**Table 1-2—U.S. EPR Conformance with Standard Review Plan (NUREG-0800)**

**Table 19.1-102—Summary of Insights from the PRA for the U.S. EPR**  
**Sheet 1 of 11**

**19.1.4.1.2 Results from the Level 1 PRA for Operations at Power**

Figure 19.1-5—U.S. EPR Level 1 Internal Events Uncertainty Analysis Results – Cumulative Distributions for Internal Events CDF

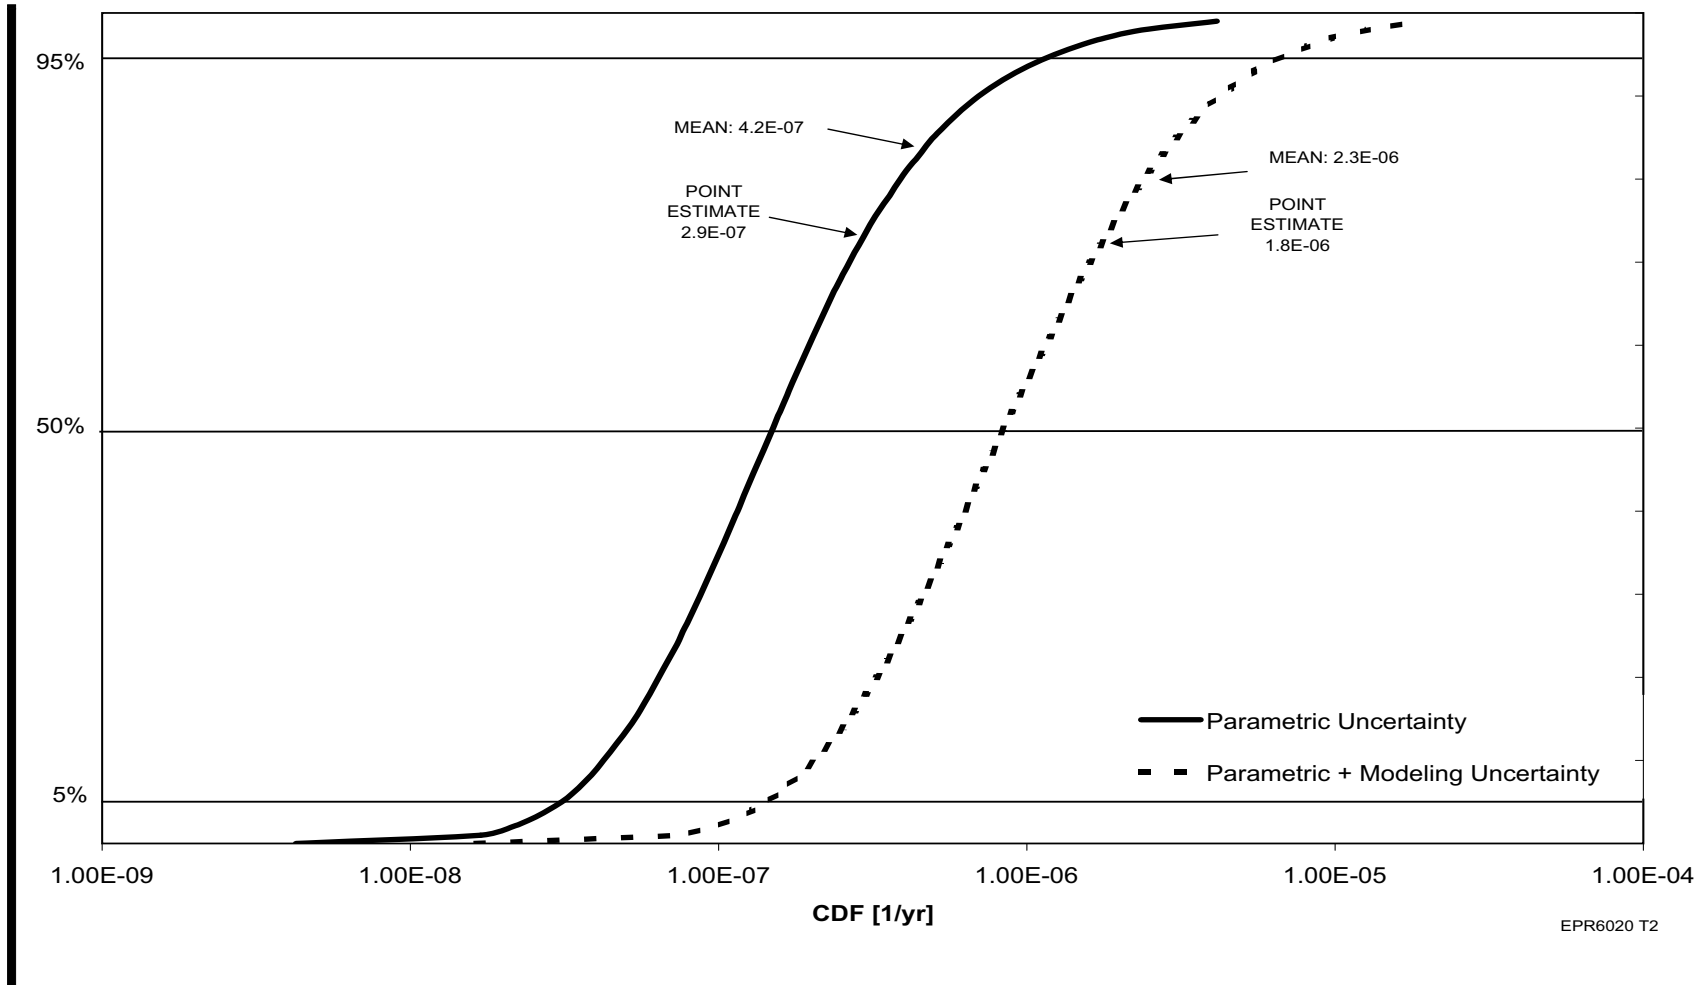
~~The results of the uncertainty analysis for internal events are shown in Figure 19.1-5—U.S. EPR Level 1 Events Uncertainty Analysis Results—Cumulative Distributions for Internal Events CDF. Three distributions are presented, one that only incorporates parametric uncertainty; one that incorporates three cases of modeling uncertainty, and the one that incorporates parametric uncertainty, but w/o distribution on DG failures to run (a point estimate is used only). The reason that this curve is presented is discussed next:~~

~~As can be seen from the results for parametric uncertainty, the mean value from the Monte Carlo simulation is significantly larger than the point estimate. This is due to the “state of knowledge correlation” as defined in the ASME PRA Standards, which is most important for cutsets that contain multiple basic events whose probabilities are based on the same data, particularly when the uncertainty of the parameter value is large. Given the redundancy of the U.S. EPR safety trains, such cutsets are common in the U.S. EPR PRA model. For example, cutsets with multiple DG failures to run may include up to six basic events with the same data. In this case, in the Monte Carlo~~

~~sampling approach, the same value is used for each basic event probability, since the “state of knowledge” about the parameter value is the same for each event. This results in a mean value for the joint probability that is larger than the product of the mean values of the event probabilities. To illustrate this, a Monte Carlo simulation is performed after eliminating uncertainty connected with DG failure rates to run (a point estimate is used). As illustrated in Figure 19.1-5, this assumption had significantly reduced the mean value which is now very close to the point estimate value. It is an interesting conclusion: redundancy in the important safety trains reduces overall risk, but increases degrees of uncertainty.~~

Uncertainty on the Level 1 Internal Events PRA results is quantified using the built-in uncertainty analysis capabilities of Risk Spectrum. ~~This PRA uncertainty quantification evaluates parametric uncertainty. Modeling uncertainty is addressed with limited scope in a separate uncertainty evaluation.~~ The results are shown in Figure 19.1-5—U.S. EPR Level 1 Events Uncertainty Analysis Results – Cumulative Distributions for Internal Events CDF. Two distributions are presented, one that only incorporates parametric uncertainty and one that incorporates three cases of modeling uncertainty. The results of parametric uncertainty are summarized below:

- CDF Internal Events Mean Value: 4.2E-07/yr.
- CDF Internal Events 5% Value: 3.1E-08/yr.
- CDF Internal Events 95% Value: 1.2E-06/yr.

Figure 19.1-9—U.S. EPR Level 2 Internal Events Uncertainty Analysis Results — Cumulative Distribution for  
Internal Events ~~Function for~~ LRF

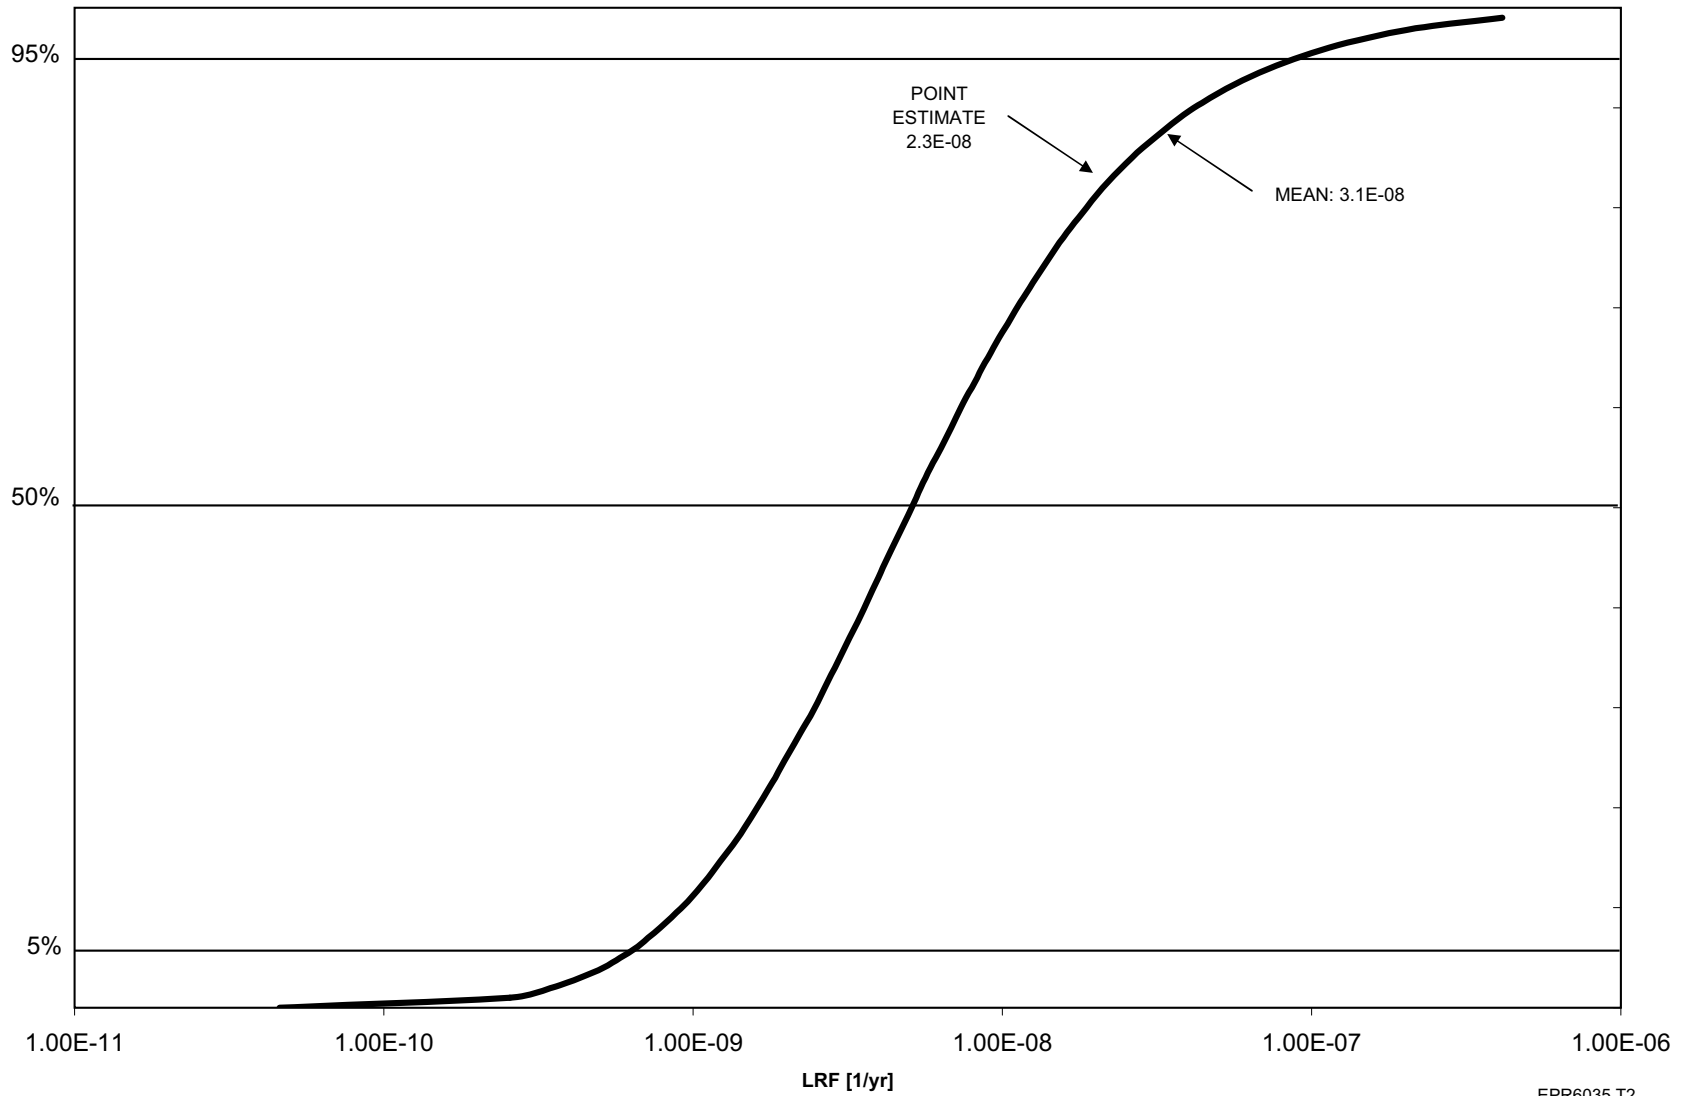
~~An integrated uncertainty analysis was performed for the U.S. EPR Level 1 and Level 2 PRAs. The results of the uncertainty evaluation for the Level 2 Internal Events LRF are presented in Figure 19.1-9—Level 2 Internal Events Uncertainty – Cumulative Distribution for LRF.~~

~~The results of the uncertainty evaluation for the LRF are presented in Figure 19.1-9—Level 2 Internal Events Uncertainty—Cumulative Distribution Function for LRF. The fifth percentile for the LRF is 1.3E-9/yr. The ninety fifth percentile is 9.7E-8/yr. This ninety fifth percentile LRF value is more than an order of magnitude below the goal of 1E-6/yr.~~

- LRF Internal Events Mean Value: 3.1E-08/yr.
- LRF Internal Events 5% Value: 5.8E-10/yr.
- LRF Internal Events 95% Value: 9.0E-08/yr.

Figure 19.1-13—U.S. EPR Level 1 Internal Flooding Events Uncertainty Analysis Results— Cumulative Distribution for Flood Events CDF

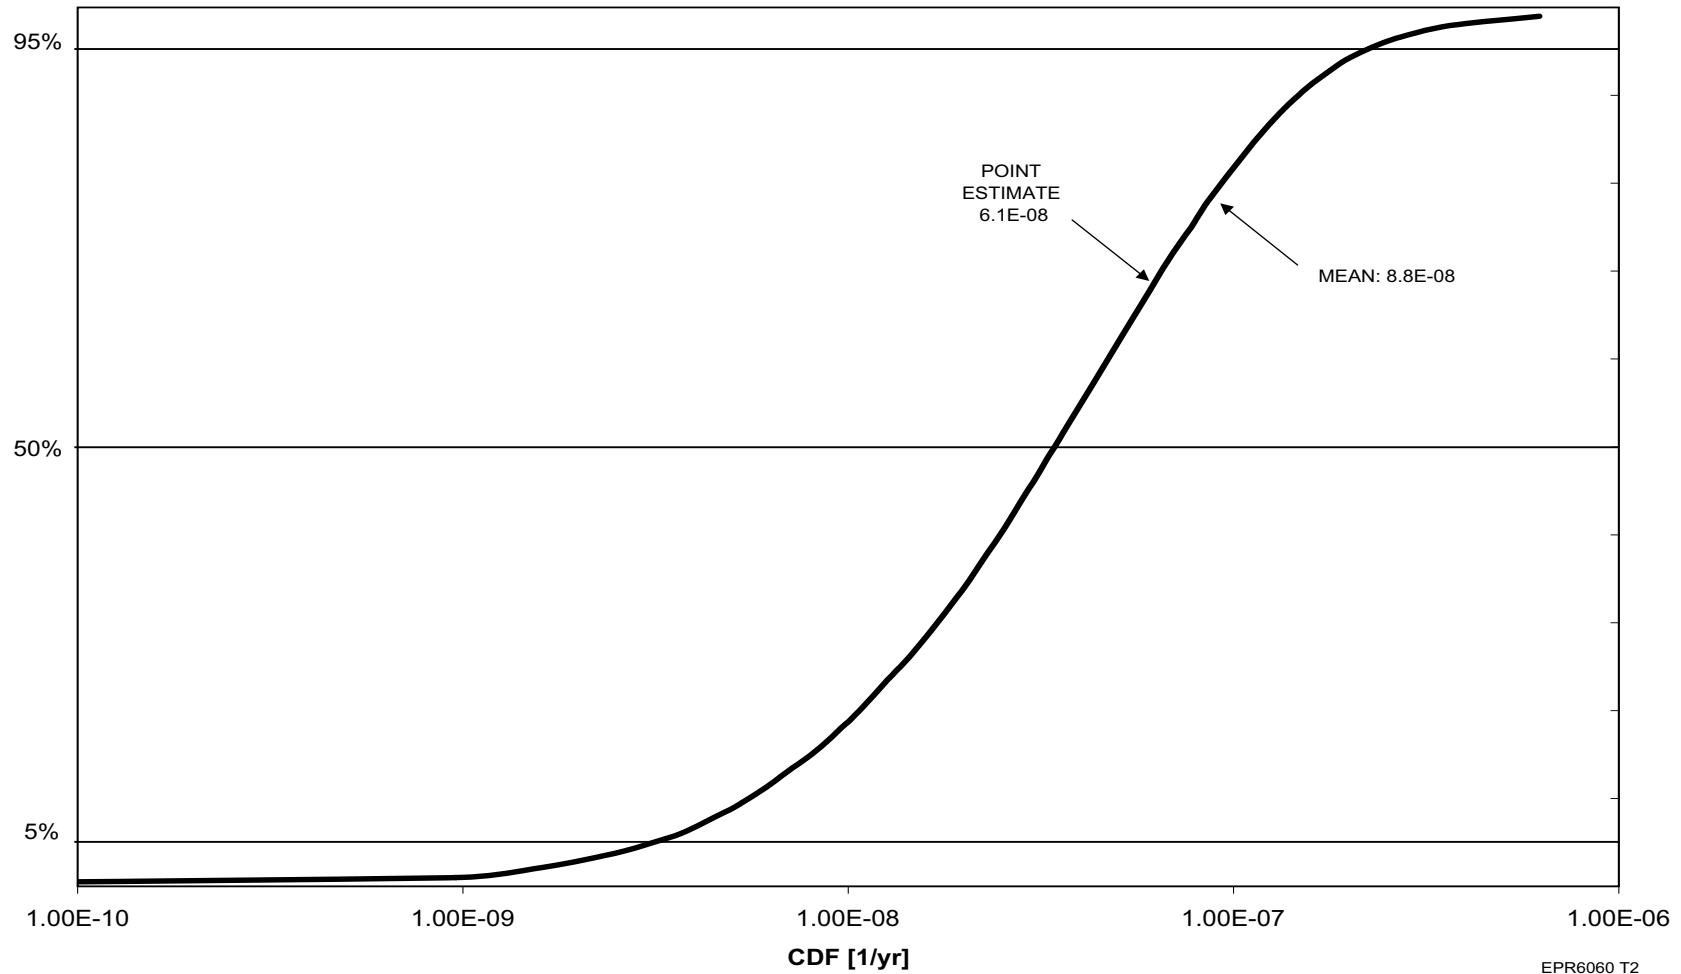
~~The results of the uncertainty analysis for flooding events are shown in Figure 19.1-13—U.S. EPR Internal Flooding Events Uncertainty Analysis Results—Cumulative Distribution Function for CDF. Two distributions are presented, one that~~

The results of the uncertainty evaluation for the Level 1 Flooding Events CDF are presented in Figure 19.1-13—U.S. EPR Internal Flooding Events Uncertainty Analysis Results – Cumulative Distribution for Flood Events CDF.

- CDF Internal Flooding Events Mean Value: 6.1E-08/yr.
- CDF Internal Flooding Events 5% Value: 3.1E-09/yr.
- CDF Internal Flooding Events 95% Value: 2.2E-07/yr.

Figure 19.1-14—U.S. EPR Level 2 Flooding Events Uncertainty Analysis Results – Cumulative Distribution for Flood Events Function for LRF

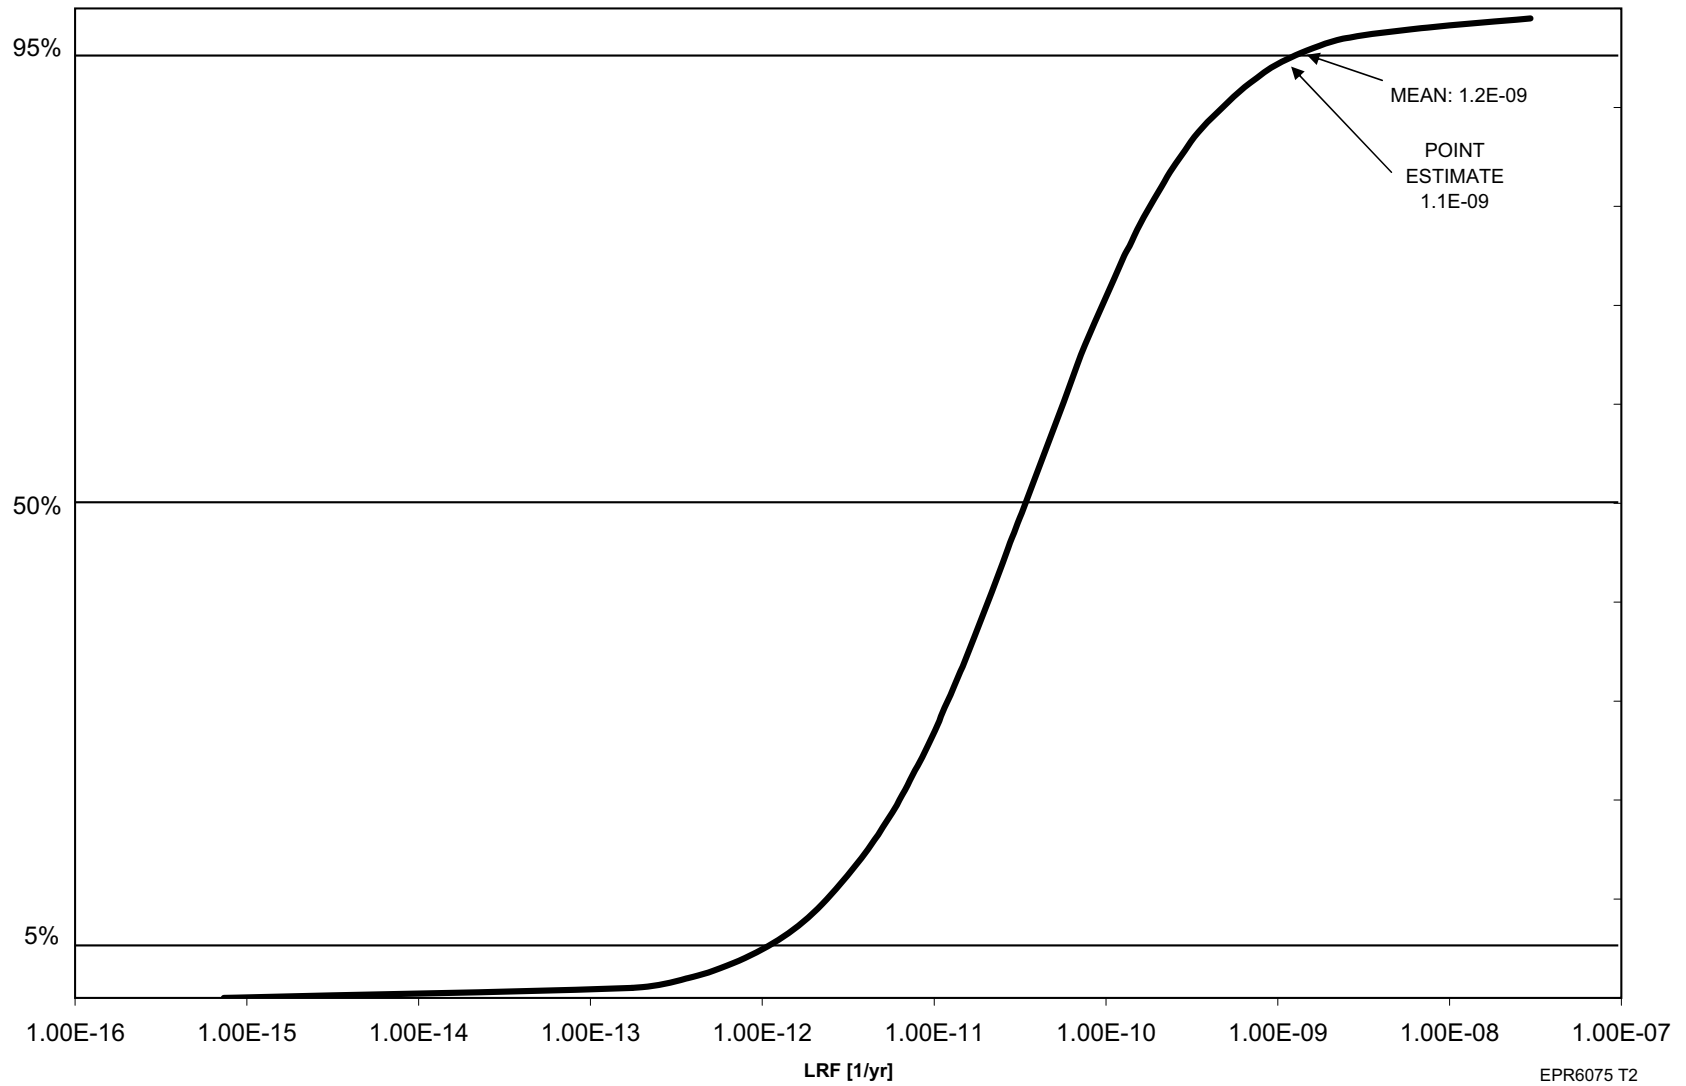
~~The results of the uncertainty evaluation for the LRF for floods are presented in Figure 19.1-14—U.S. EPR Level 2 Flooding Events Uncertainty Analysis Results—Cumulative Distribution Function for CDF. The fifth percentile for the LRF is  $1.5E-10$ /yr. The ninety fifth percentile is  $3.4E-9$ /yr. This ninety fifth percentile LRF value is more than two orders of magnitude below the goal of  $1E-6$ /yr~~

The results of the uncertainty evaluation for the Level 2 Flooding Events LRF are presented in Figure 19.1-14 —U.S. EPR Level 2 Flooding Events Uncertainty Analysis Results – Cumulative Distribution for CDF.

Figure 19.1-18—U.S. EPR Level 1 Internal Fire Events Uncertainty Analysis Results — Cumulative Distribution for Fire Events CDF

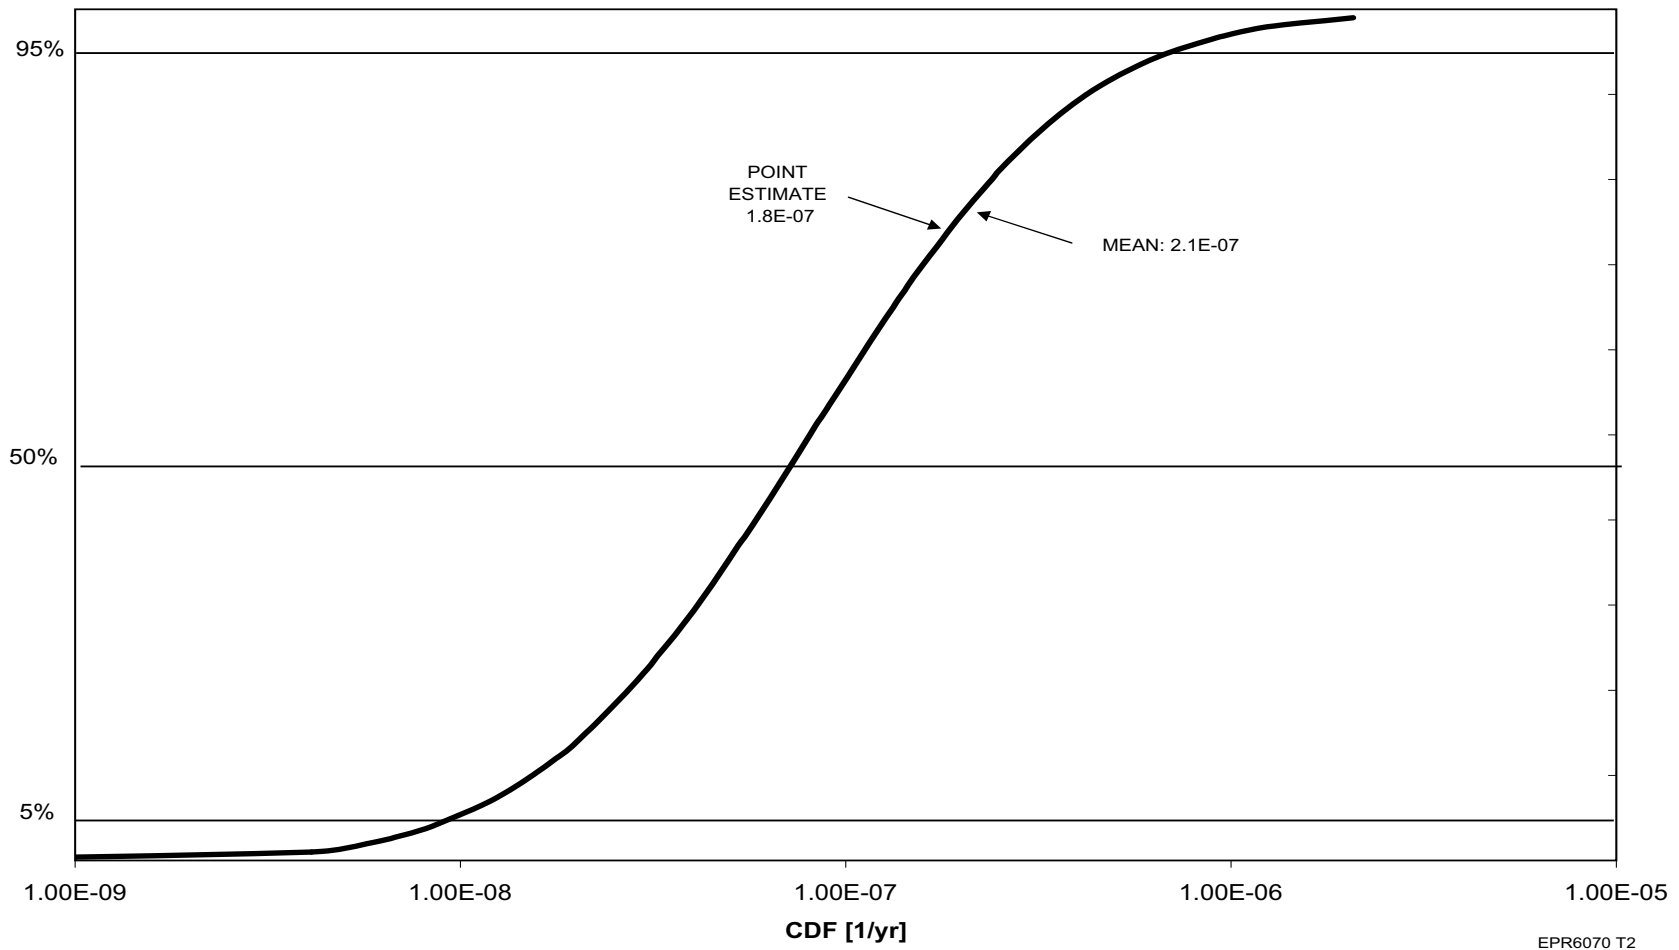
~~The results of the uncertainty analysis for fire events are shown in Figure 19.1-18—U.S. EPR Level 1 Internal Fire Events Uncertainty Analysis Results—Cumulative Distribution for Fire Events CDF. Two distributions are presented: one that only incorporates parametric uncertainty and one that incorporates the three cases of~~

The results of the uncertainty evaluation for the Level 1 Fire Events CDF are presented in Figure 19.1-18—U.S. EPR Level 1 Internal Fire Events Uncertainty Analysis Results – Cumulative Distribution for Fire Events CDF.
